To: Steele, Tania (CWS)
Subject: Rock Lake Colony Domestic Wastewater Treatment Lagoon File: 5059.00

Re: Rock Lake Holding Ltd. – Wastewater Treatment Lagoon – Environment Act Proposal (File: 5059.00)

Re: Rock Lake Holding Ltd. - Domestic Wastewater Treatment Lagoon - Environment Act Proposal

**Rock Lake Colony Lagoon
S.E. 1/4 Sec. 1-13-1W.
R.M. of Woodlands**

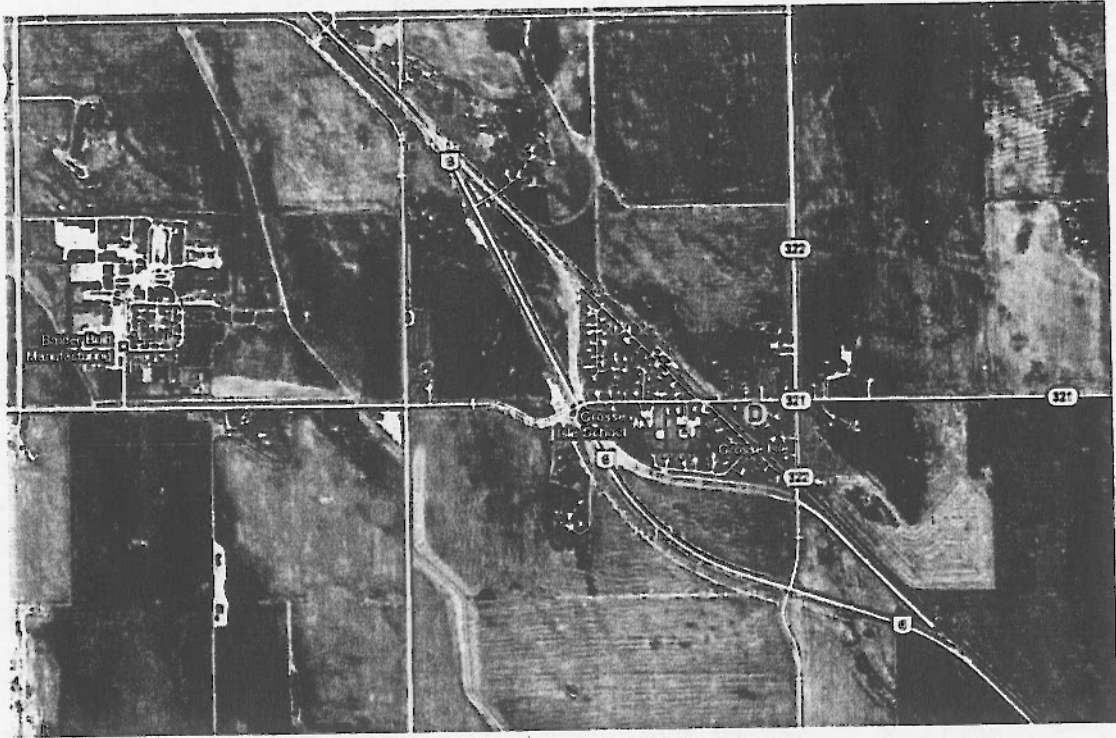
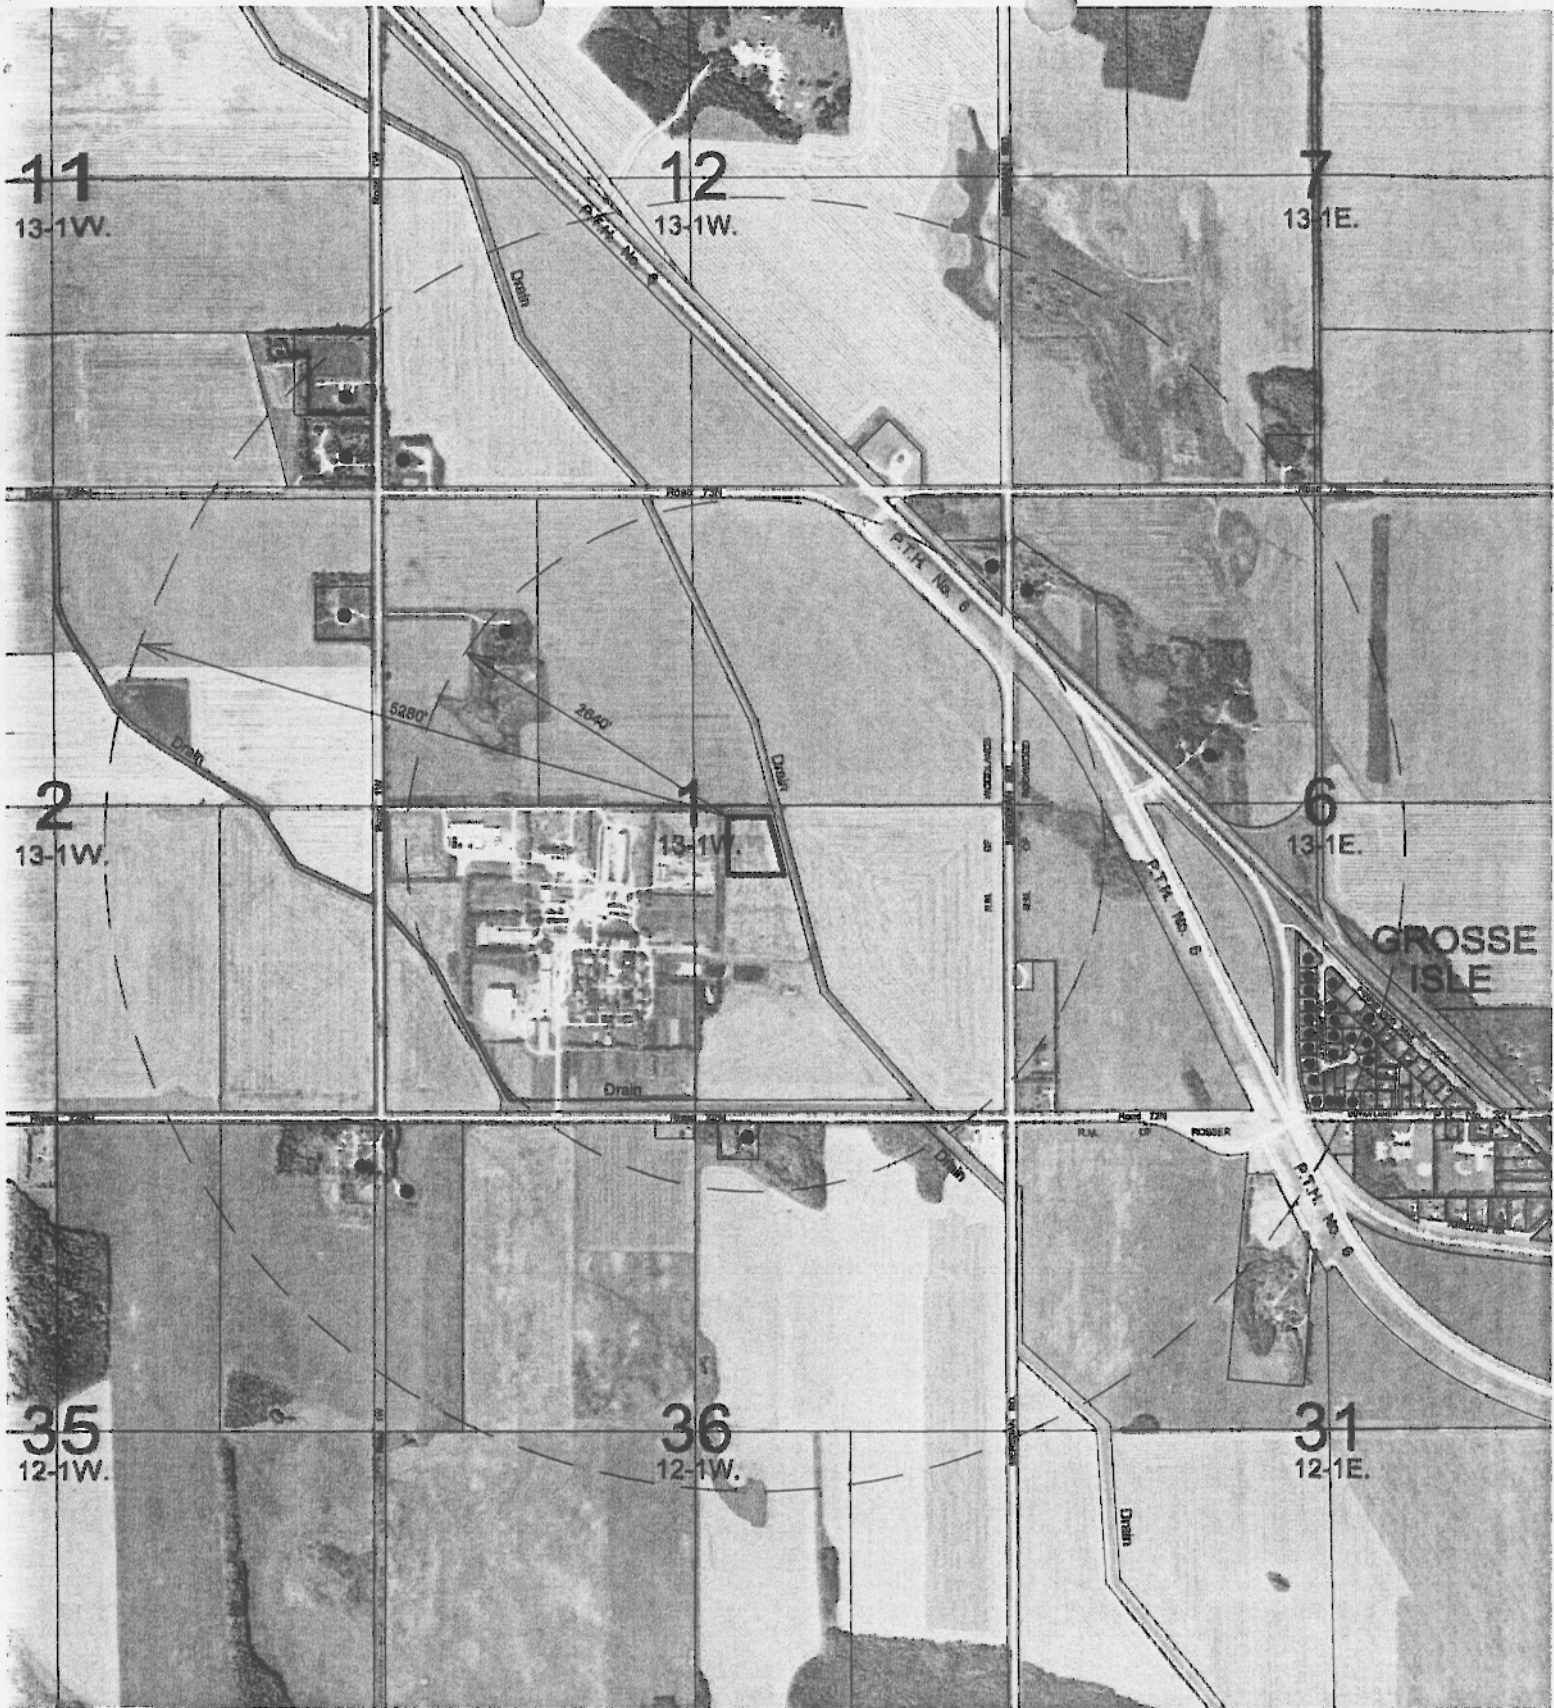
The proposed lagoon site is located within the Rural Municipality of Woodlands, and in proximity to the boundaries between the Rural Municipalities of Woodlands, Rockwood and Rosser. The community of Grosse Isle, which spans the municipalities of Rockwood and Rosser, is approximately 1 mile southeast of the proposed site. Assessment records indicate 2 dwellings within 2640 feet of the proposed lagoon and 31 dwellings between 2640 and 5280 feet of the lagoon. Please see the attached.

- 2 Dwellings within 2640' of lagoon
- 31 Dwellings between 2640' and 5280' of lagoon
